Re: Product Safety Recall – GM / Pleasurecraft Engine Group 8.1L gasoline marine engines

#SUPEG-1006-01

#060083T

8.1L Fuel Rail Pulse Dampener Clip Replacement

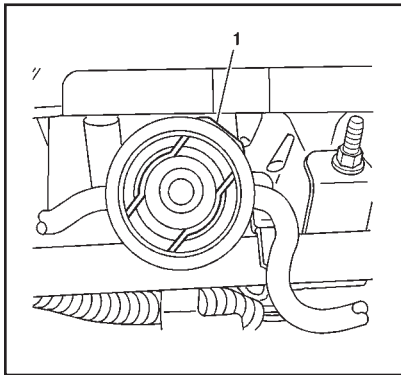
8. Clean any dirt from the fuel pressure dampener (i.e. damper) retainer (clip) and the surrounding area.

9. Push down on the fuel dampener and remove the fuel pressure dampener clip (1) and discard.

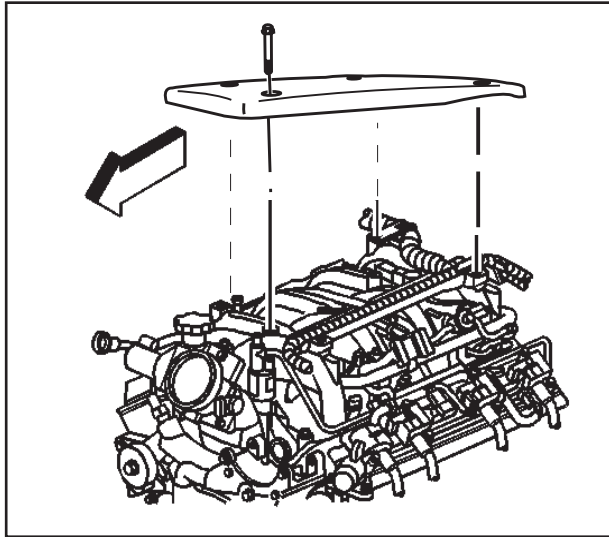
When installing the new Fuel Rail Pulse Dampener Clip, ensure the clip is retained in the guide slots on BOTH sides of the Pulse Dampener Housing. If both clip ends are not in the guide slot, the Pulse Dampener may come loose and a fuel leak may result which could, under certain circumstances, cause a fire and/or explosion.

10. Push down on the fuel dampener and install the new fuel pressure dampener clip (1).
11. Connect the negative battery cable.
12. Use the following procedure to inspect for leaks. Follow these steps exactly as presented. **DO NOT start the engine until you are instructed to do so.** You must verify there are no fuel leaks during the fuel pump priming sequence before proceeding further.
